REVISIONS				
ZONE	REV	DESCRIPTION	DATE	APPROVED
F5,7	B	UDTD VIEW A-A: DIM (2.59 ± .50) WAS (2.32). UDTD VIEW B-B: ADD NOTE 6,7 AND ZONE A CALLOUT. 18901 (NA)	18 MAY 89	
D7	C	ADD MOD STAT TBL. 13758(M)	21 FEB 90	
	D	MOD STAT TBL: ADD MOD LTR B. MOD LTR A REF DOCUMENT COL, ADD FSB NUMBER. 13761(M)	20 MAR 90	
	E	MOD STATUS TBL: ADDED APPLICABLE MOD LTR COLUMN AND -901 THRU -903 RESP. 13763 (NA)	16 APR 90	
	F	MOD STAT TBL: ADD MOD LTR A FOR -903 VAR. 13676(M)	22 JUN 90	
	G	MOD STAT TBL: APPLICABLE MOD LTR COL -903 ADD MOD LTR B. 13683 (M)	08 AUG 90	
	H	MOD STAT TBL: ADD APPLICABLE MOD LTR COL -904, APPLICABLE MOD LTR COL -903 ADD MOD LTR C. 13695 (M)	07 NOV 90	
	K	MOD STAT TBL: ADD APPLICABLE MOD LTR COL -905, APPLICABLE MOD LTR COL -904, ADD MOD LTR B, RELOCATE MOD TBL TO SH B. 41033 (NA)	08 JAN 92

MODIFICATION STATUS TABLE						
APPLICABLE MOD LTR					REF DOCUMENT	AFFECTED SUB ASSEMBLY
-905	-904	-903	-902	-901		
		A			FSB 21-3834-01	INTERCHANGED ALT TYP SEL A WAS XA2-66, AND B, WAS XA2-154, ON MOTHERBOARD TO MEET ARINC 718 ALT TYP SEL NOMENCLATURE.
			B		FSB 21-3834-02	CHANGED A2-U54 FROM -101 TO -103, BLOCKS NON-TESTED VIDEO PATH DURING MODE S SELF TEST. REDUCED TRANSMIT DETECTOR

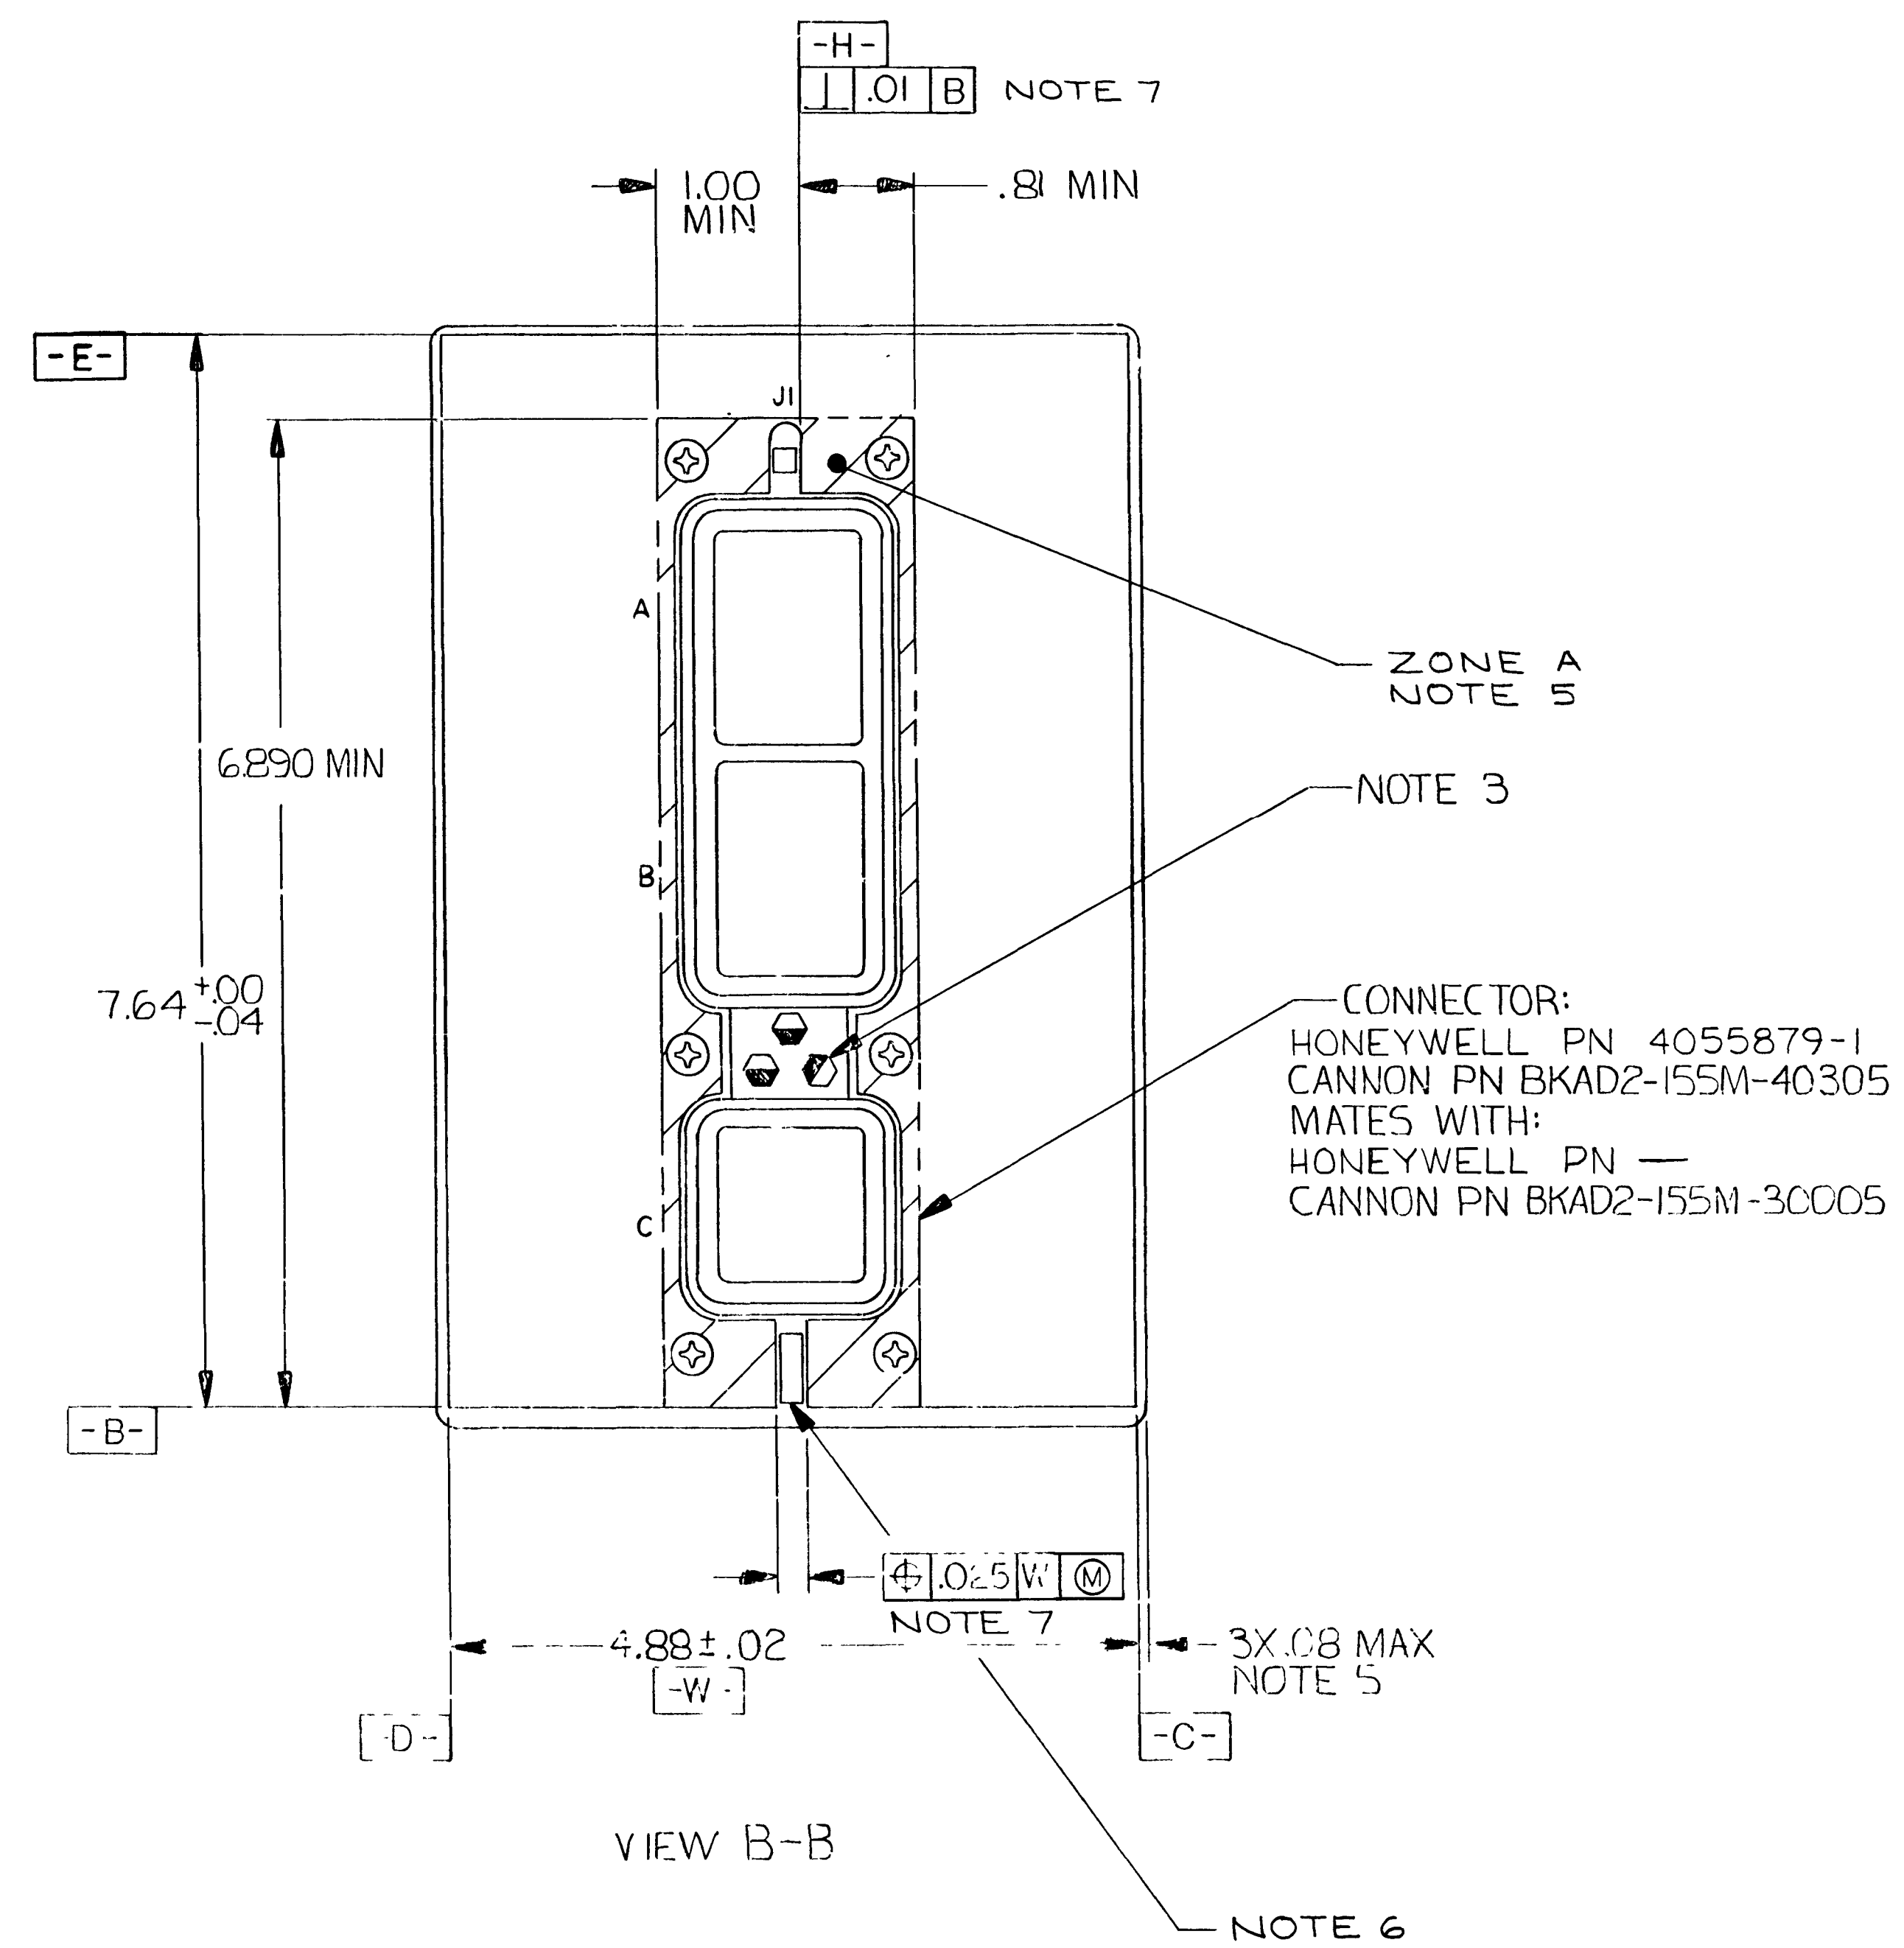
B				FSB 21-3834-08	IMPROVES POWER INTERRUPT PERFORMANCE BY INCREASING NOISE IMMUNITY IN THE POWER SUPPLY.
A					FSB 24-3834-08 21-3834-09	NEW SOFTWARE, PART NUMBER PS4067467-907, TO INCORPORATE CHANGE 3 REQUIREMENTS. IMPROVES POWER INTERRUPT PERFORMANCE BY INCREASING NOISE IMMUNITY IN THE POWER SUPPLY.
